Jacob's Ladder
Stream Restoration Monitoring Report
DMS Project # 95023
DMS Contract # 003983
Monitoring Year 05

MEMORANDUM

Subject: Jacob's Ladder Stream Restoration Site
MY-05 Monitoring Report Comments
Yadkin River Basin CU 03040105
Rowan County, North Carolina
NCDMS Project # 95023
Contract # 003983

DATE: JAN 2019
SCALE: GRAPHIC
CURRENT
CONDITION
PLAN VIEW
SHEET 1 OF 2

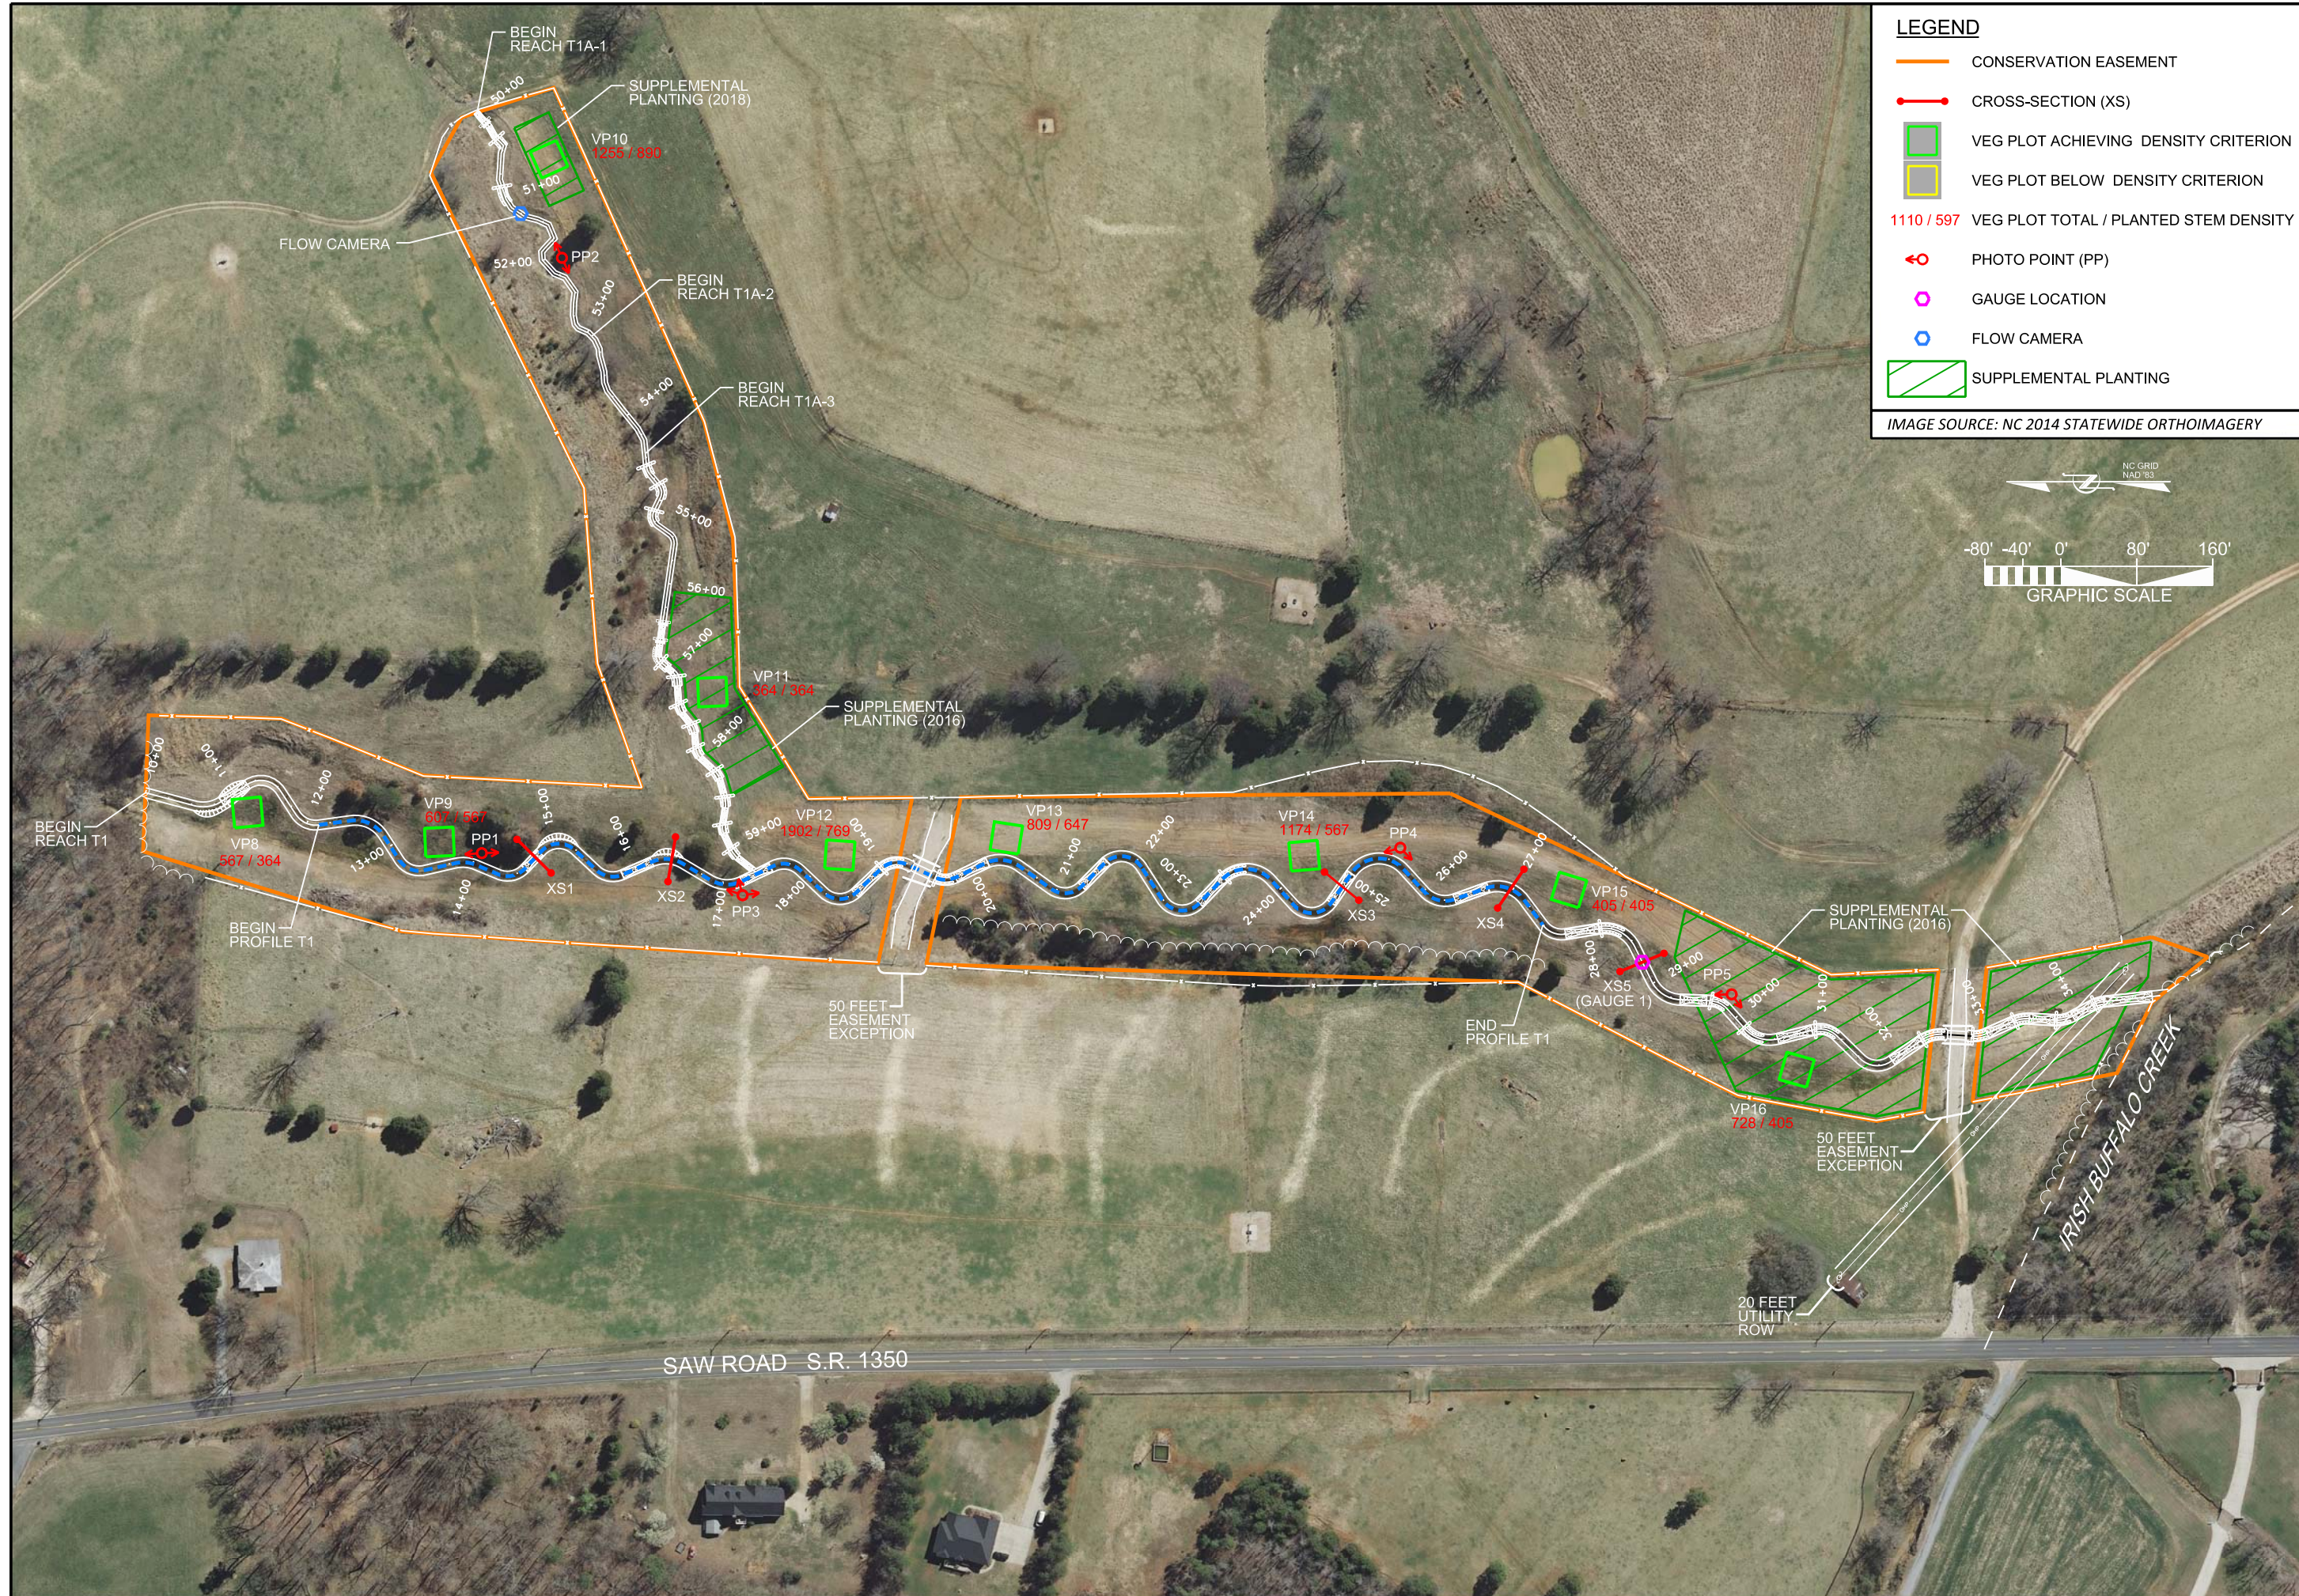
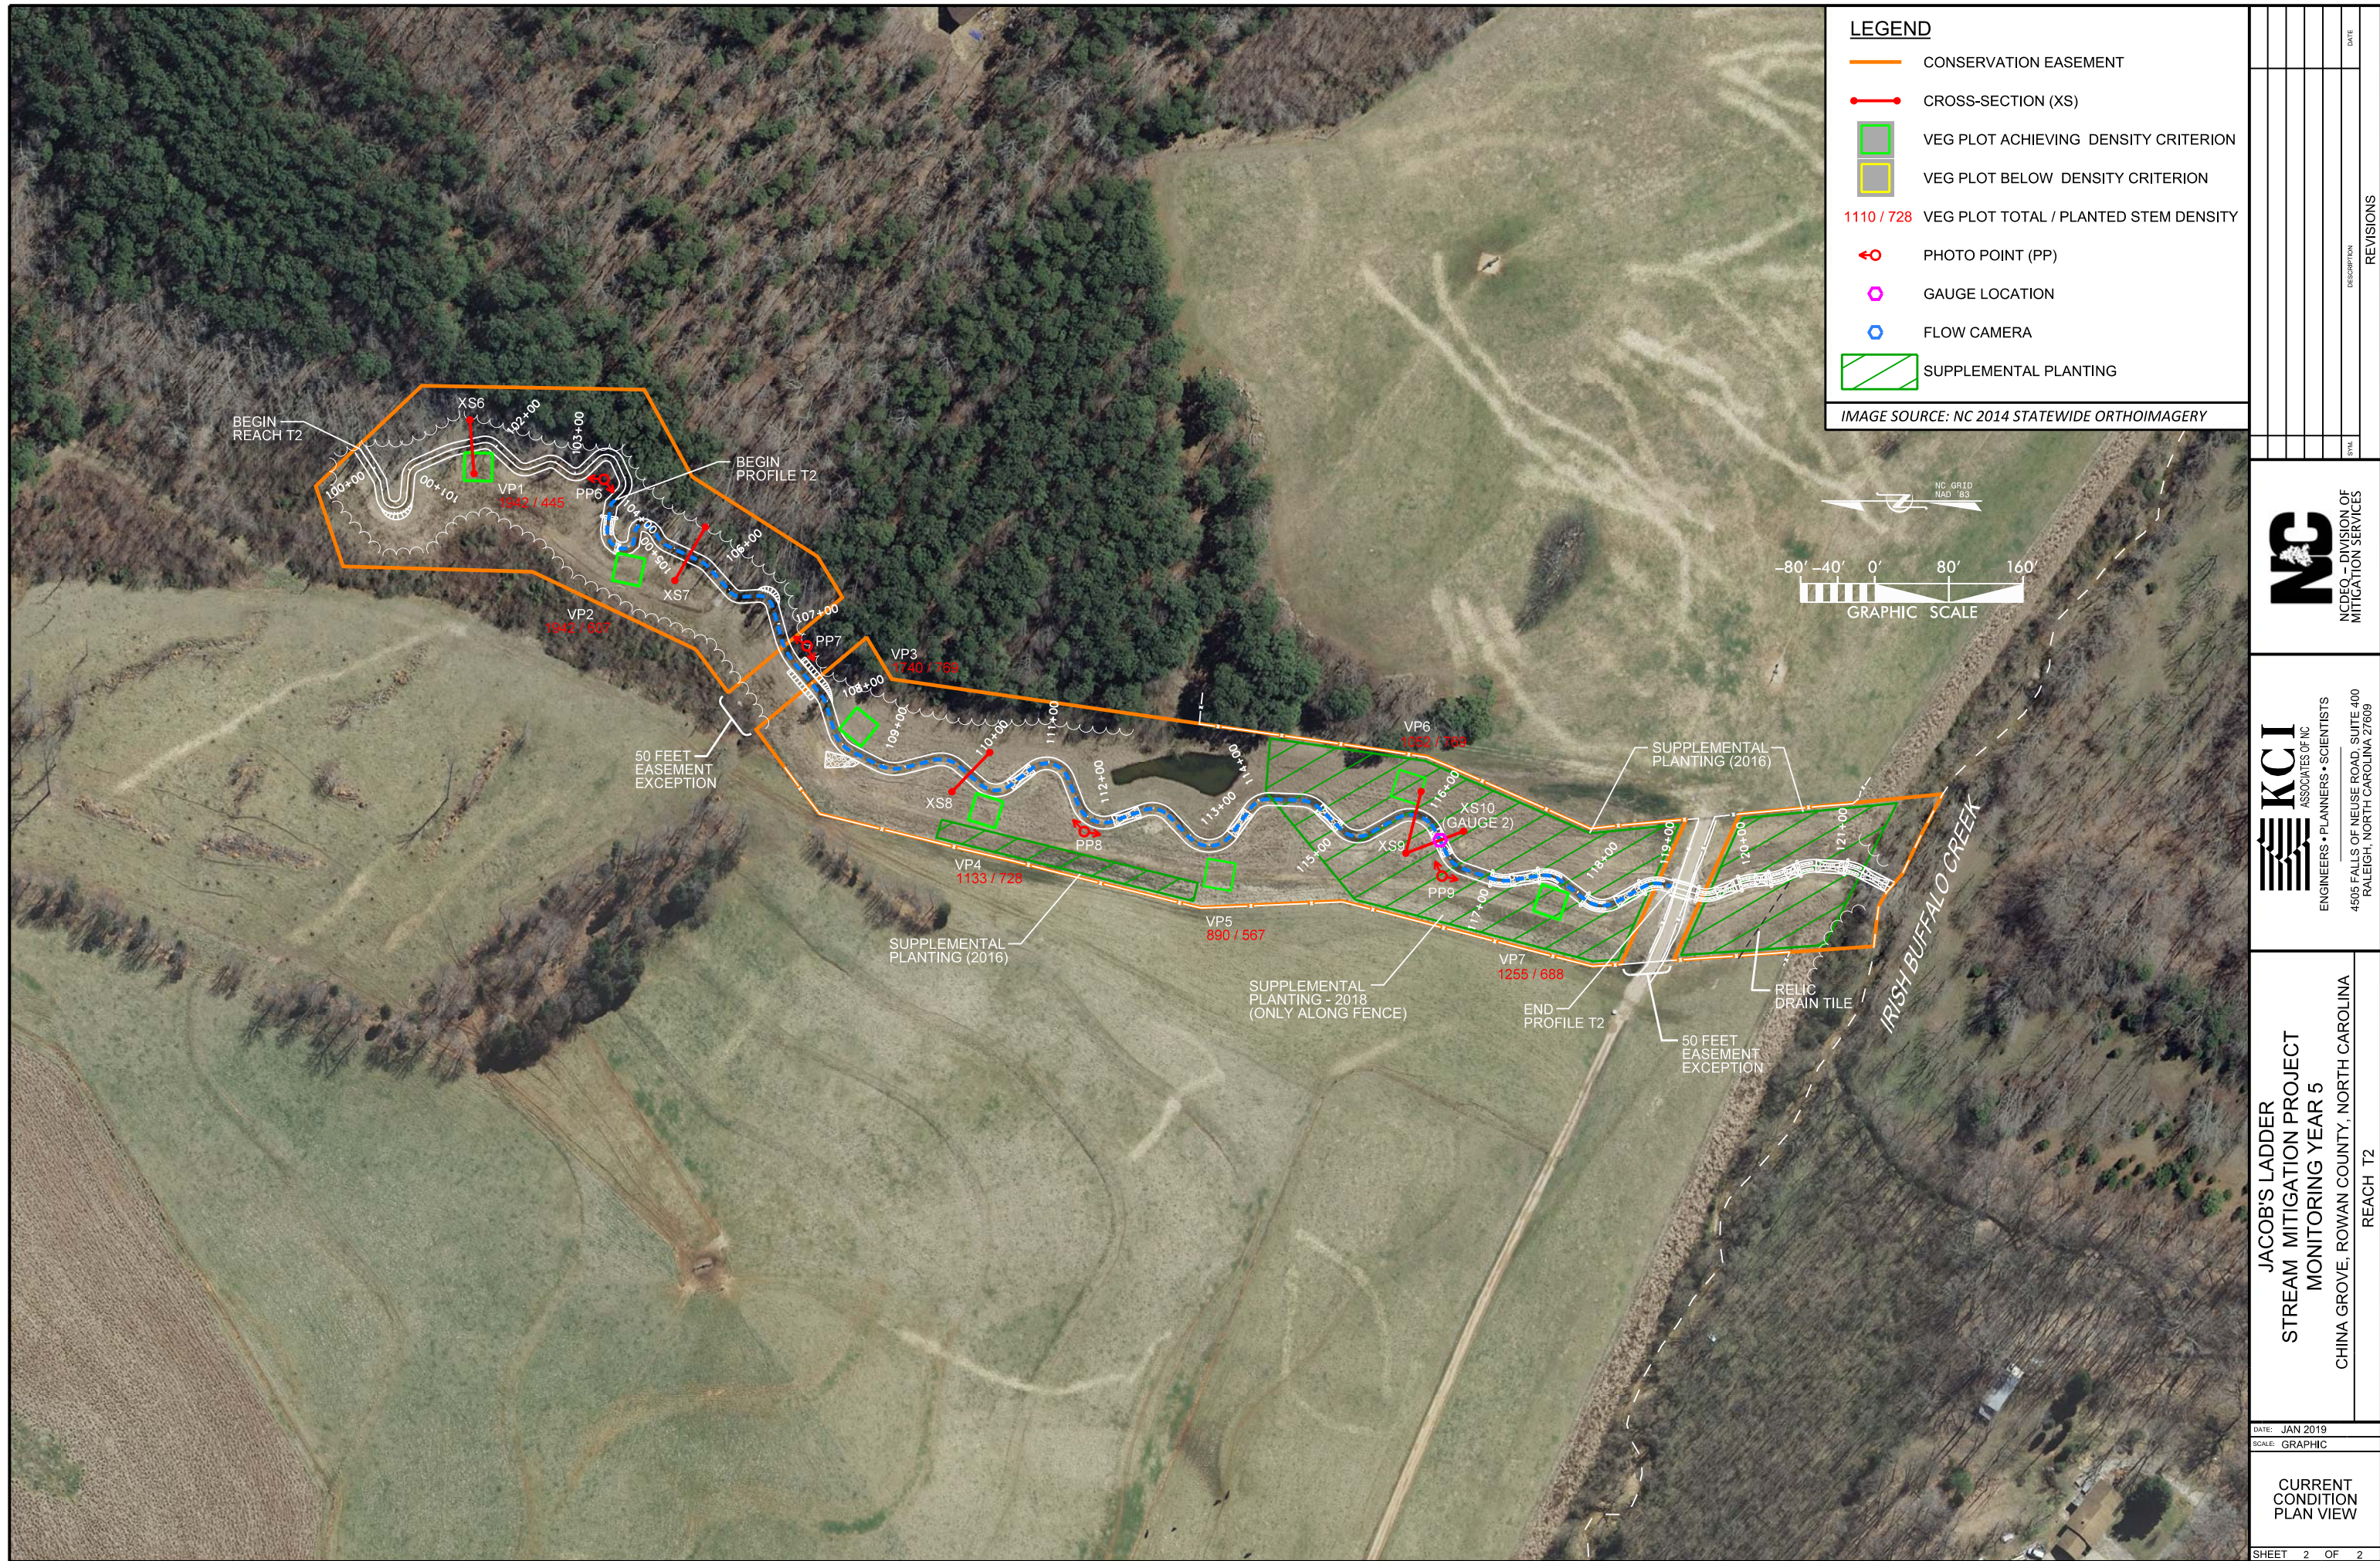
The report discusses a supplemental planting that occurred in 2015; however, there are supplemental plantings that occurred in 2016 and 2018 according to the CCPV. Please update discussion in report to reflect these plantings. A short discussion regarding size, quantity and species would be helpful.

Add location of camera on T1A to CCPV and any additional monitoring devices that may have been installed.

A drain tile was located on T2 near 120+50. Please add this to the CCPV. Also, as discussed at the December 4, 2018 meeting, the tile will need to be located and a shapefile provided to Jeff Horton so it is adequately documented with Stewardship.

- *Two supplemental plantings occurred, one in April 2016 and one in April 2018. The reference to a 2015 supplemental planting has been corrected and a brief discussion of the extent of each planting has been added to the report.*

- *The camera at the top of T1A appears on the CCPV. Two additional cameras were installed on T1A, but since no data was available from them at the time this report was put together they aren't shown on the CCPV. They will appear in the closeout report, along with the data gathered from them.*

- *This has been added to the CCPV and a shapefile has been provided to Jeff Horton.*
